## UNITED STATES PATENT AND TRADEMARK OFFICE

APPLICATION NO.	FILING DATE	FIRST NAMED INVENTOR	ATTORNEY DOCKET NO.	CONFIRMATION NO.
10/646,545	08/21/2003	Douglas S. Hine	P-11138.00	9714
7590 Elisabeth L. Belden Medronic, Inc. 7000 Central Ave., N.E. Mailstop B408 Minneapolis, MN 55432		12/19/2008	EXAMINER ALTER, ALYSSA MARGO	
			ART UNIT 3762	PAPER NUMBER PAPER
			MAIL DATE 12/19/2008	DELIVERY MODE PAPER

<b>Office Action Summary</b>	<b>Application No.</b> 10/646,545	<b>Applicant(s)</b> HINE ET AL.
	<b>Examiner</b> Alyssa M. Alter	<b>Art Unit</b> 3762

### **DETAILED ACTION**

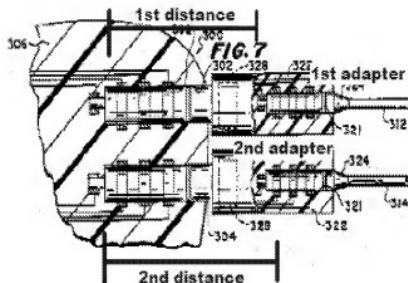
1. Claims 1, 3-4, 6, 11-13 and 15 are rejected under 35 U.S.C. 102(b) as anticipated by or, in the alternative, under 35 U.S.C. 103(a) as obvious Pohndorf et al. (US 4,628,934). Pohndorf et al. discloses a pacemaker with a connector bore for electrically and mechanically connecting the implantable medical device (IMD) with two adapters and multi-electrode leads as displayed in figures 6 and 7. The adapters upsize the leads prior to the insertion into the connector bore within the IMD. The array of lead connector elements are displayed in figure 2 as "sleeves 151 and 152 (in contact with

rings 141 and 142) (col. 7, lines 63-64)". The sleeves are connected to electrodes, with a conductor for each electrode. The two adaptors, which the examiner considers to be a plurality of adaptors, have an inner lumen for engaging the sleeves of the lead with rings to create an electrical and mechanical connection. In addition, the adaptors have an external surface used for engagement with the electrical bore. This engagement surface has two contact zones, the pin as the first zone and sleeves of the lead as the second zone, which connects within the IMD with the socket and rings, respectively.

As to claims 1 and 11, the examiner has included a replication of figure 7 to display the first and second distances. The examiner considers the first distance is to the first contact zone and the second distance is to the second contact zone. Therefore the first distance is not equal to the second distance.
